Supplemental Safety Evaluation
For The
General Electric Topical Report
Qualification Of The One-Dimensional
Core Transient Model For
Boiling Water Reactors
NEDO-24154 and NEDE-24154P
Volumes I, II and III

Reactor Systems Branch, DSI

January 1981

Figure 2-1. 5% Significance Coefficient (A) vs. Surveillance Data in Cycle

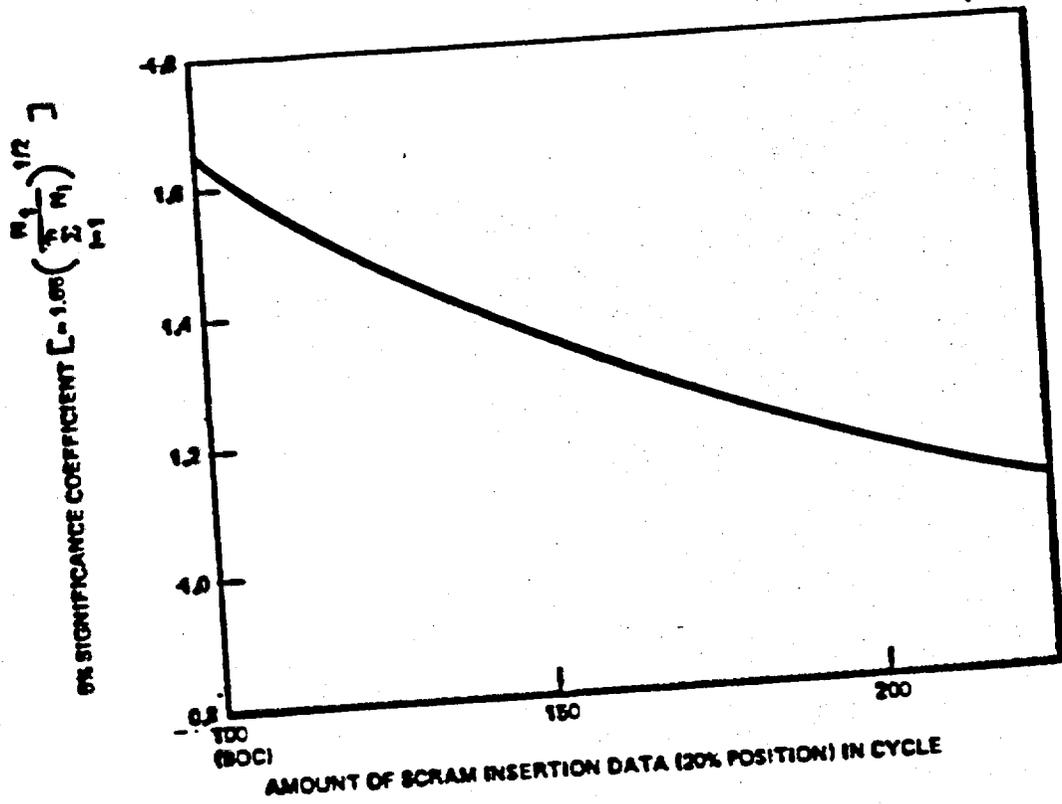
The relationship between the coefficient, A, and the amount of surveillance data generated during the cycle is illustrated in Figure 2-1. As more data become available through the performance of in-cycle surveillance tests, the coefficient decreases, as does the acceptance criterion, τ_B . Thus, the scram speed criterion is being tightened as the cycle progresses, based on the assumption that, as more scram data become available during the cycle, the uncertainty in the mean value calculation should decrease.

We find the scram insertion time conformance procedure to be acceptable.
